Rezoning Transportation Analysis

Petition Number: 2024-028

Date	Description
03-27-24	First Review (ME)

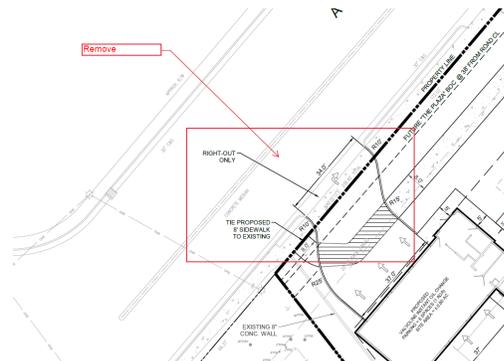
1. Curblines:

- The Plaza:** Location of curb and gutter to be located 38 feet from roadway centerline. Curblines is not to be relocated. Future Back of curb location is to be labeled and dimensioned on site plan.
- Matheson Avenue:** Future back of curb locations is to be located at 39.5 feet from roadway centerline. Location of curb and gutter to not be relocated. Future Back of curb location is to be labeled and dimensioned on site plan. Revise site plan to show correct Future back of curb location.

- Shamrock Drive:** Location of curb and gutter to be located 27 feet from roadway centerline. Curblines is not to be relocated. Future Back of curb location is to be labeled and dimensioned on site plan.

Label and dimension the curb and gutter from the centerline for each road on the site plan.

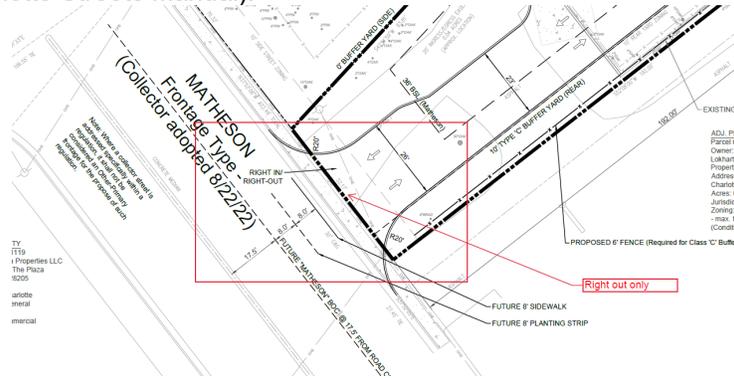
11. Revise site plan and conditional note(s) to commit to restricting the access point along Matheson Avenue right out only due to the Matheson Avenue Street Conversion project creating a drop right turn and adjacent bicycle lane approaching the signal at The Plaza (in reference to Table 2.1 and section 2.2.C of the Charlotte Streets Manual).
